LEESTON PLAN CHANGE - RFI RESPONSE

Thank you for your letter dated 19 September requesting further information regarding Plan Change PC190062: Private Plan Change Leeston. Baseline Group has prepared the following response.

Leeston Plan Change

Key

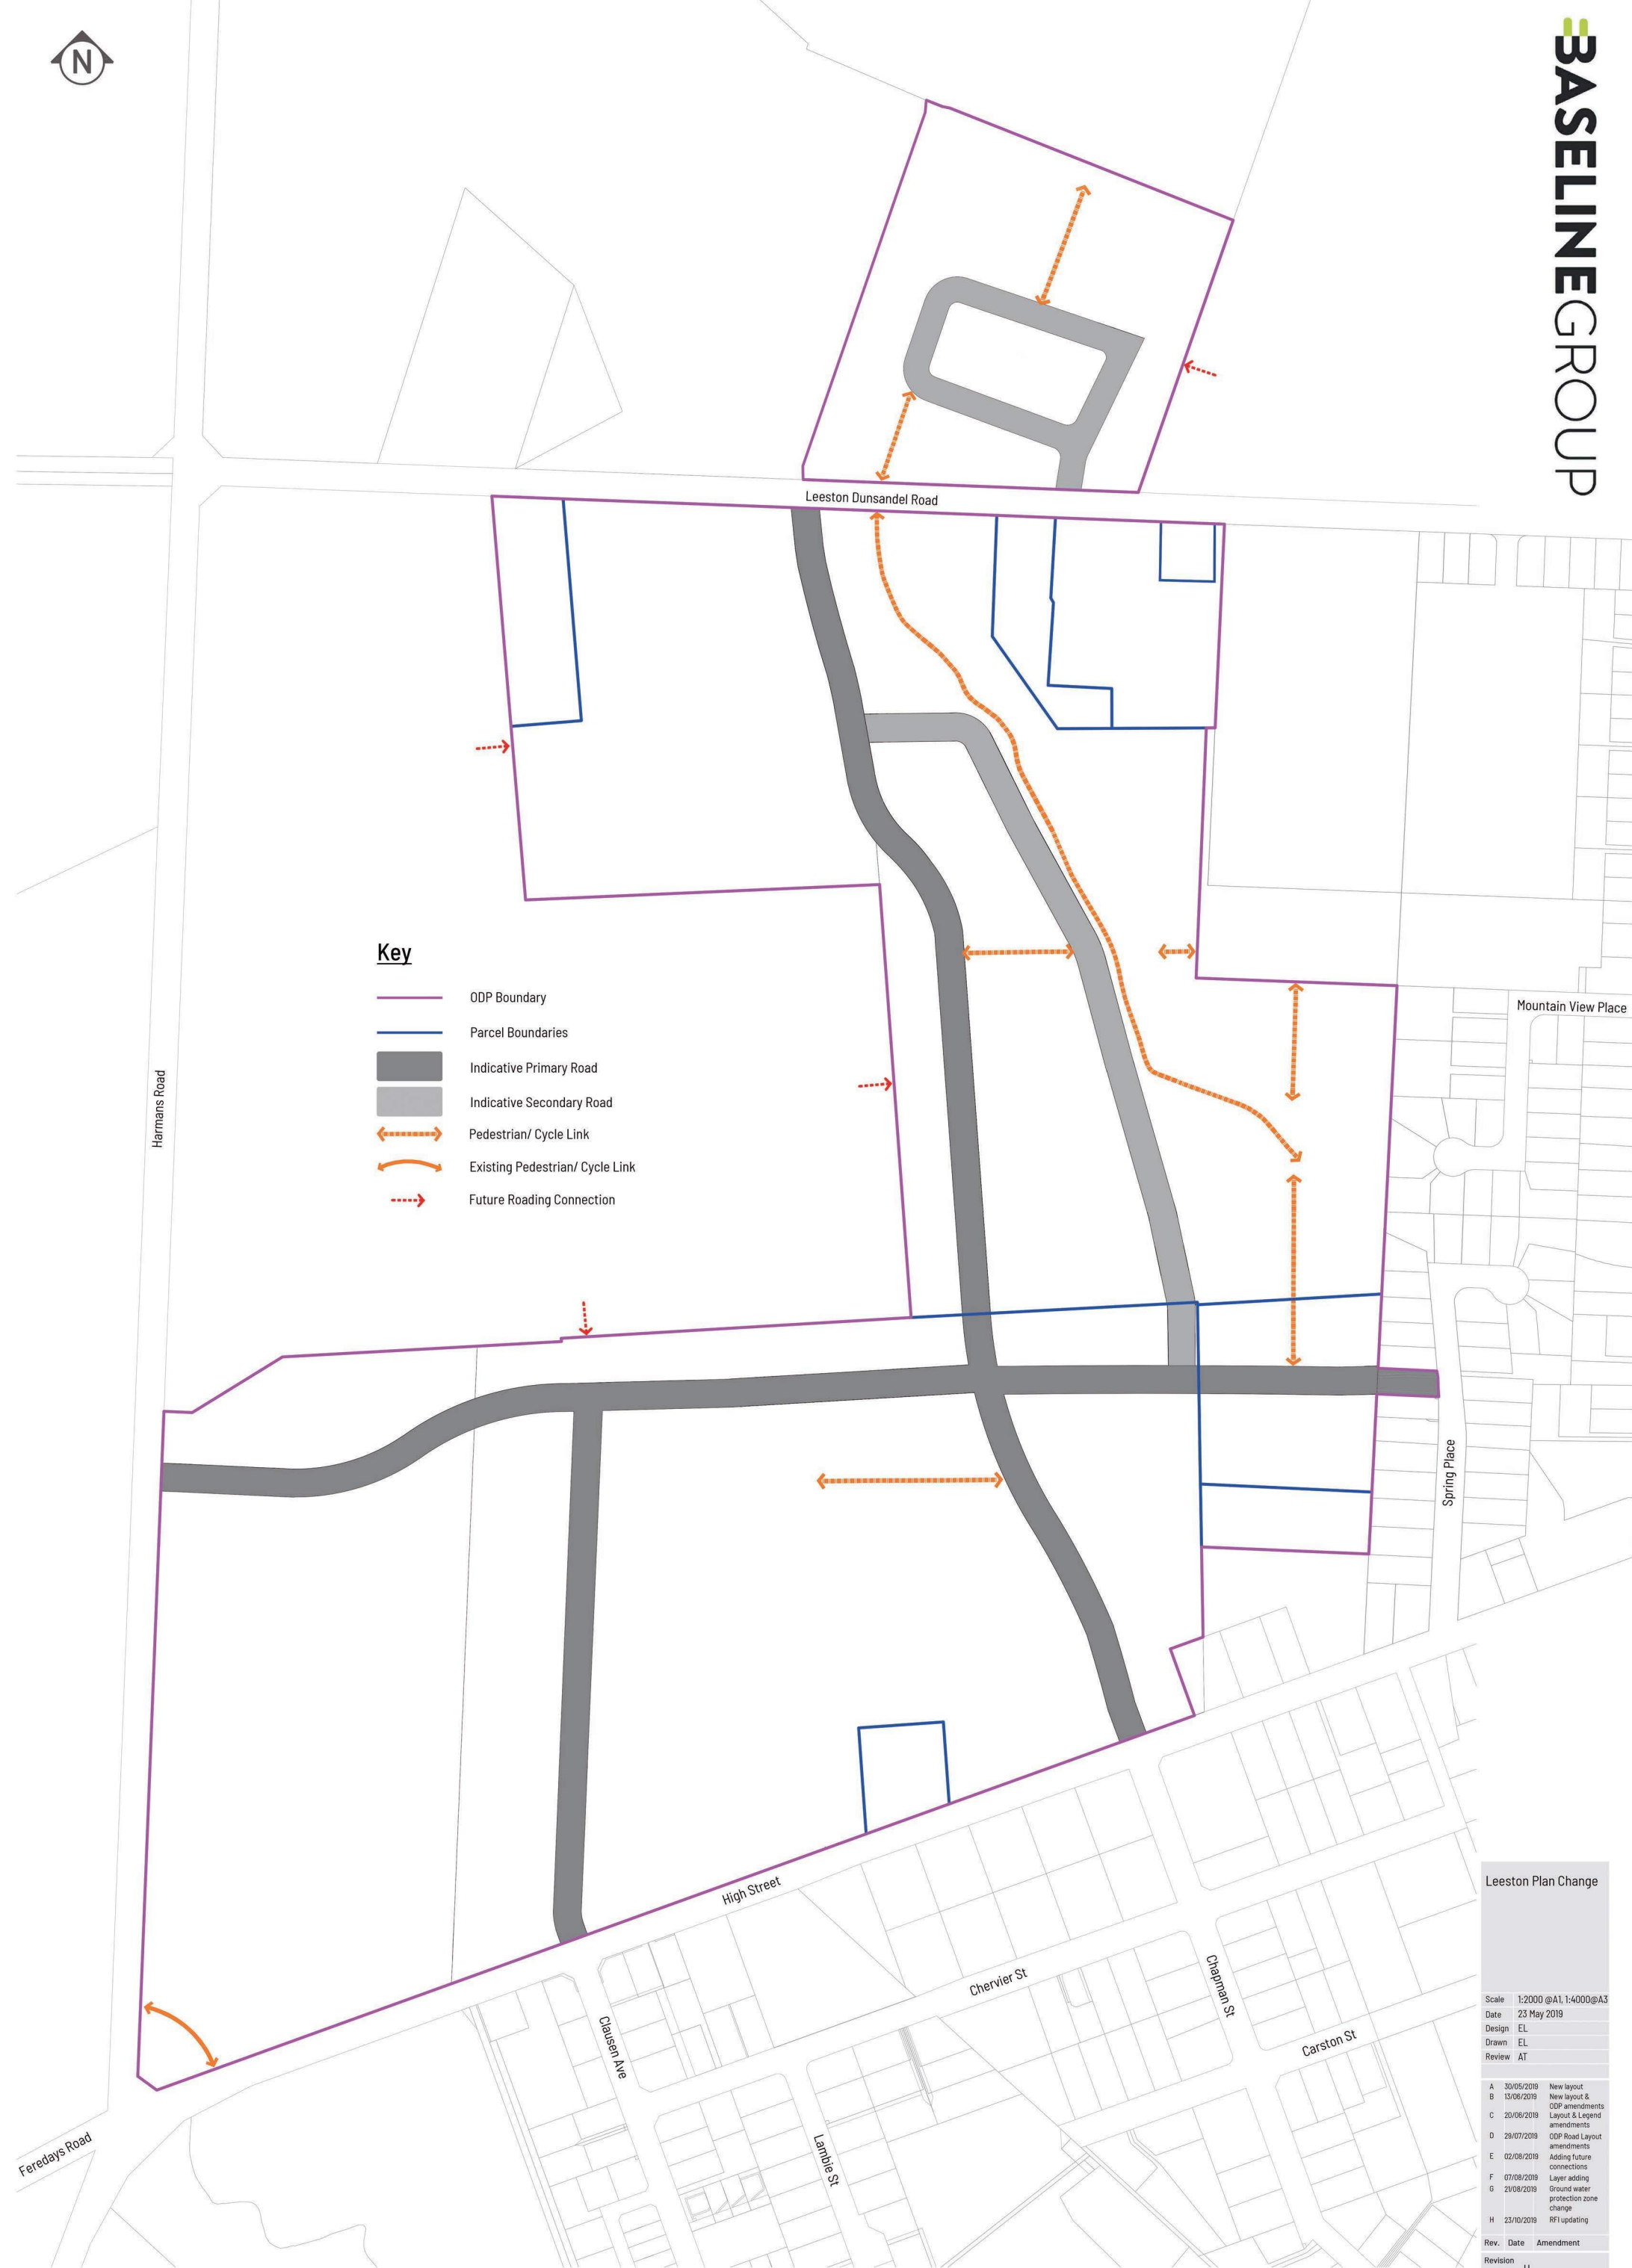
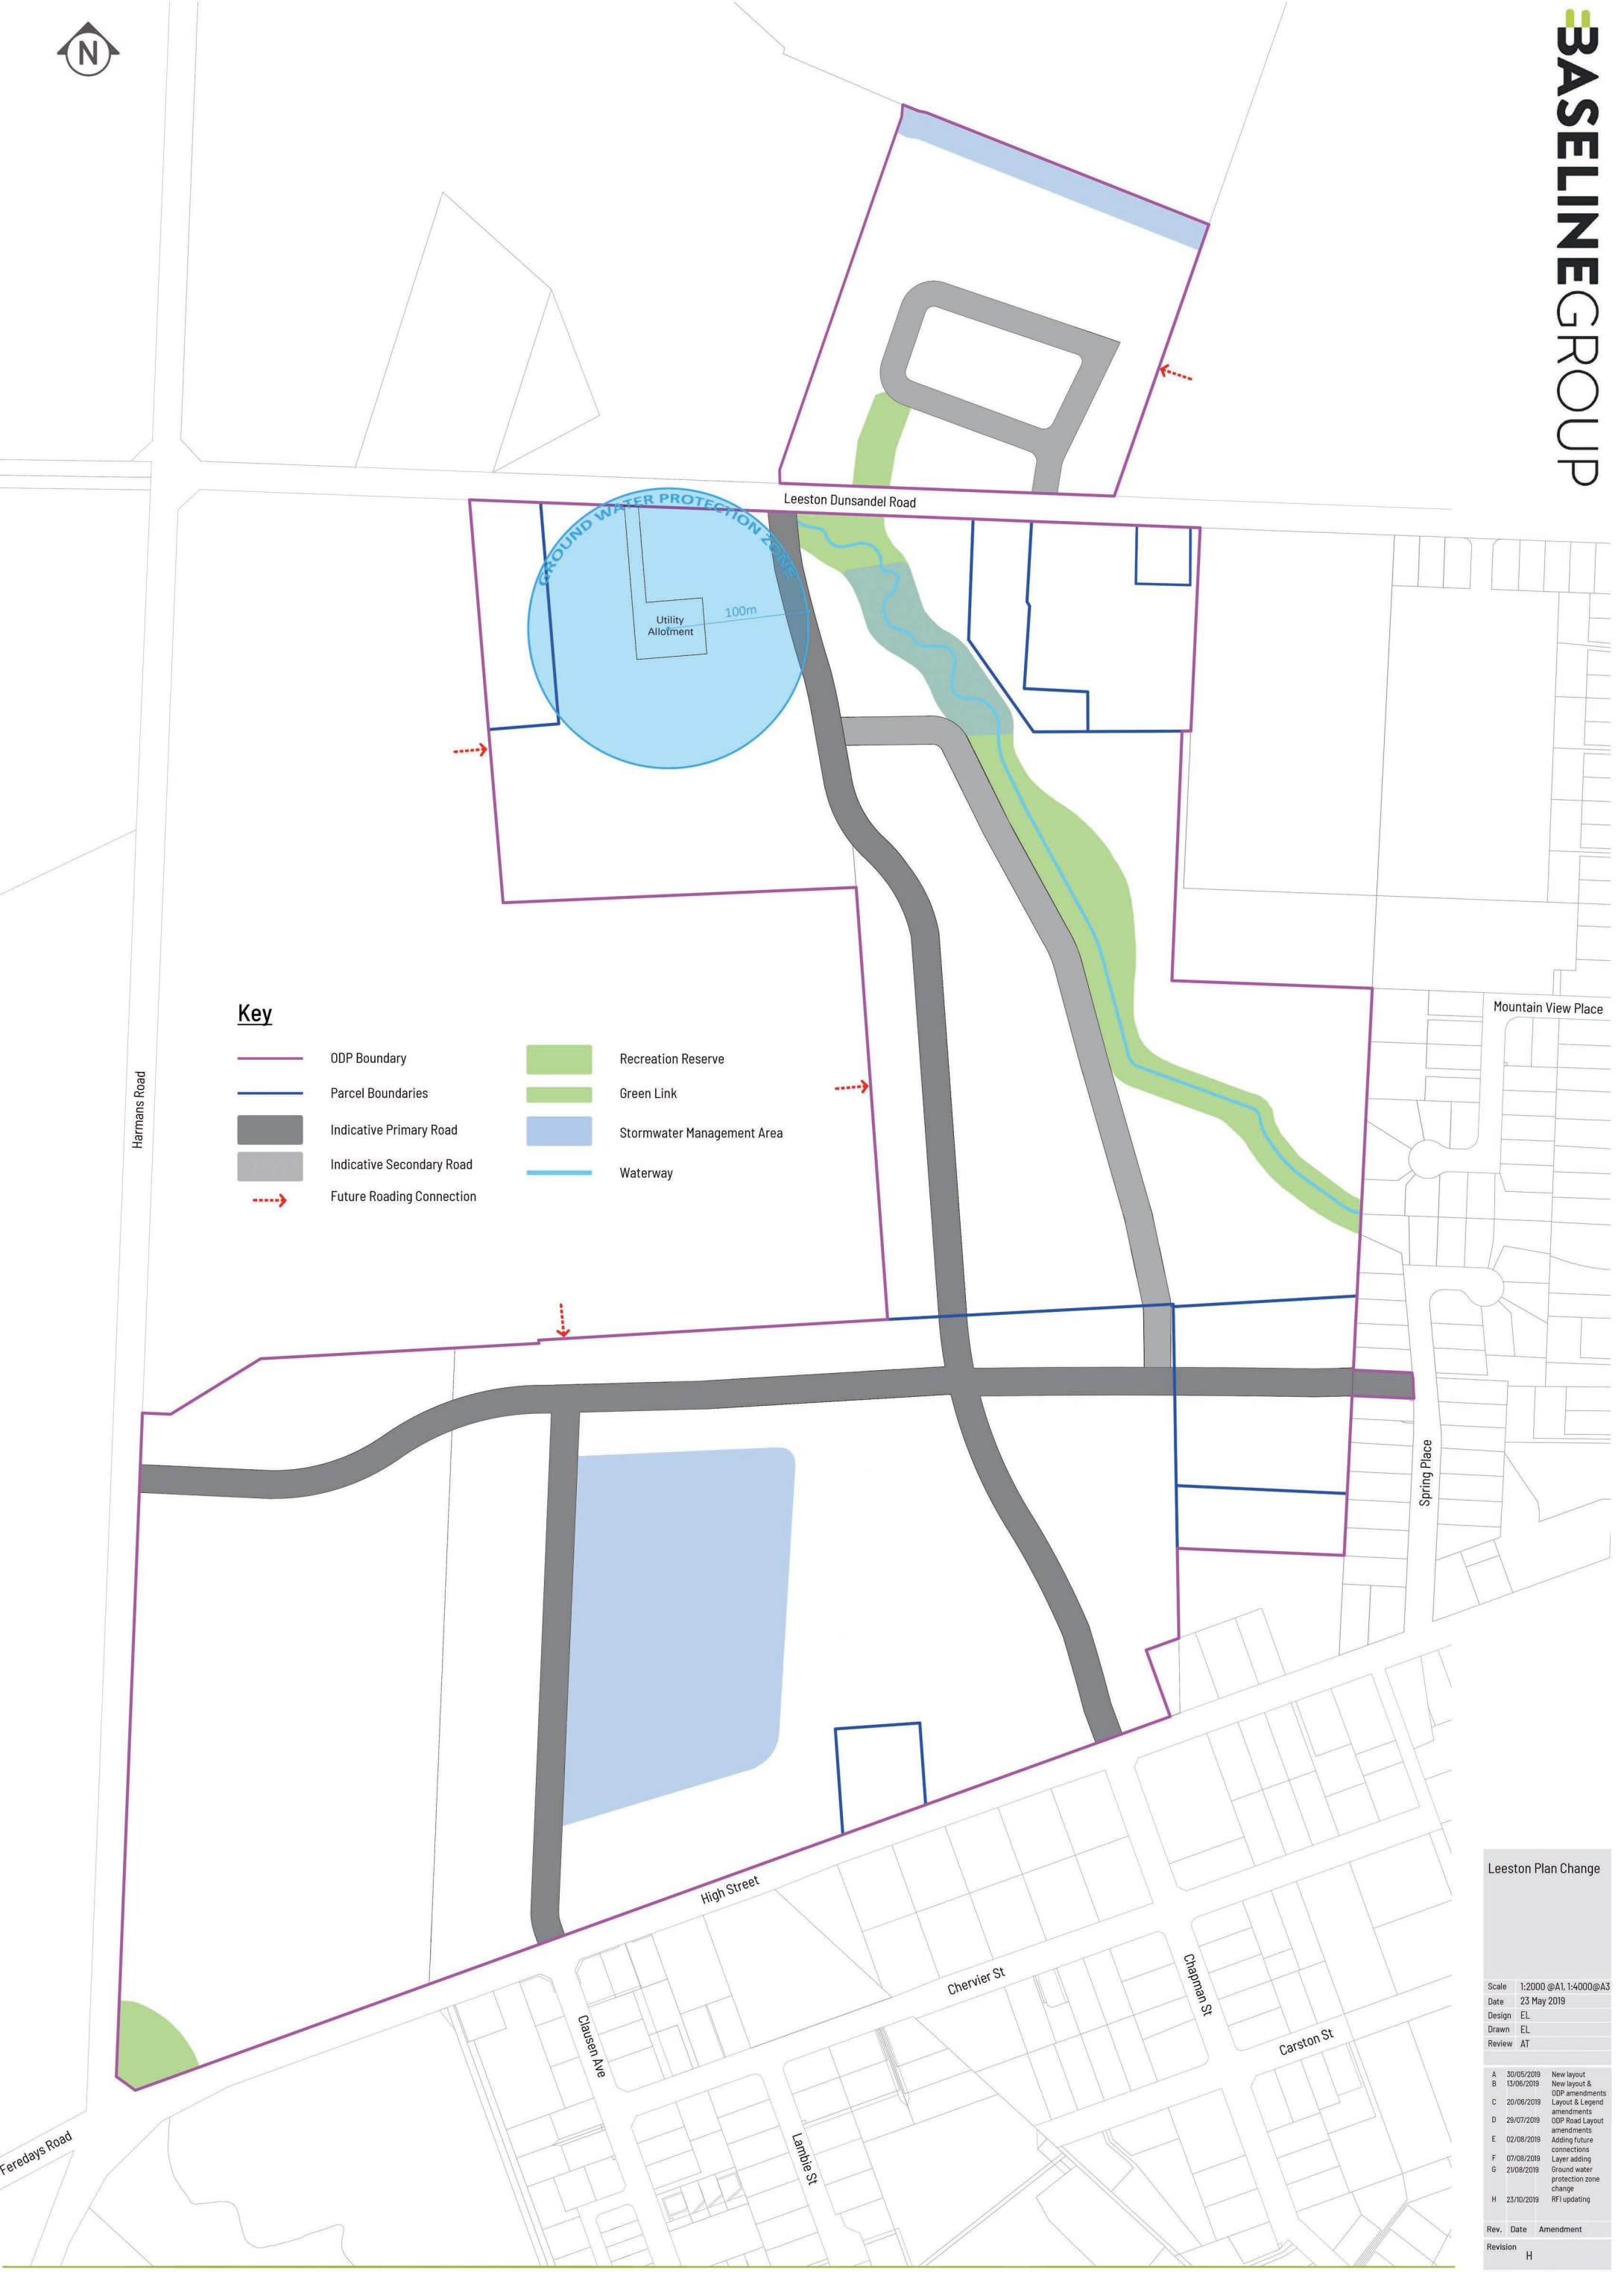
12. As highlighted in yellow below, the ODP should show a specific pedestrian/cycle link along the main reserve/water course alignment. The ODP should also show a pedestrian/cycle link from the northern part of the to the future stormwater reserve area along the northern boundary of the site.

17. There are small inconsistencies between the overall ODP and the transport network in terms of the pedestrian/cycle links. Please resolve these. It is noted that a continuous alignment is preferred.

19. The names of the surrounding roads should also be shown on the ODP.

22. The ODP should be amended to reflect any matters raised in the points above, particularly regarding roading and reserves.

These have been added to the ODP and a revised copy of the ODP is attached in Appendix 4.

The ODP has been amended to resolve the inconsistencies between the overall ODP and the transport network plan and is attached in Appendix 4.

Road names have been added to the ODP plans in Appendix 4.

The ODP plans have been amended and are attached to this letter in Appendix 4.
